**ADDENDUM  
PLANNING SUB COMMITTEE  
18 JULY 2023**

Planning Sub Committee 18 July 2023

<b>Reference No:</b> HGY/2022/2116	Ward: Hornsey
<b>Address:</b> Hornsey Police Station, 98, Tottenham Lane, London, N8 7EJ	
<b>Proposal:</b> Retention of existing Police Station building (Block A) with internal refurbishment, rear extensions and loft conversions to create 6 terrace houses and 4 flats. Erection of two buildings comprising of Block C along Glebe Road and Harold Road to create 8 flats and erection of Block B along Tottenham Lane and towards the rear of Tottenham Lane to create 7 flats and 4 mews houses including landscaping and other associated works

**Reference No:** HGY/2022/0563

**Corrected Figure 1**

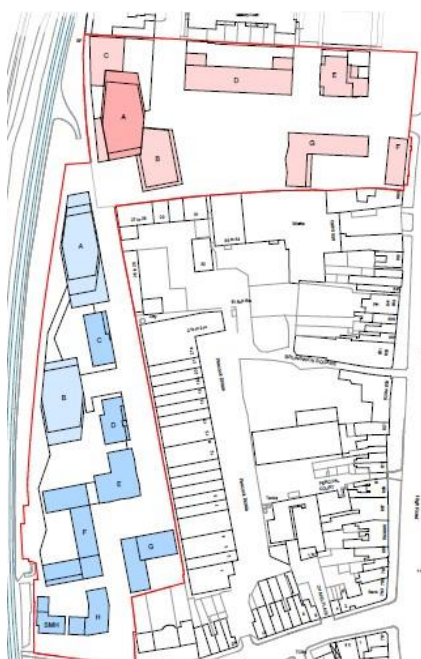
... ~~The block has been set back a further 3-7 metres from the shared boundary with the Rivers Apartments building when compared to the scheme allowed at appeal (reference HGY/2021/1771).~~ **The 5 storey Depot Block B (the block closest to Rivers Apartments) is in an identical position to allowed appeal scheme (HGY/2021/1771). Depot Block A has been moved further south (away from Rivers Apartments) than the appeal scheme positioning.** See Figure 02 below.
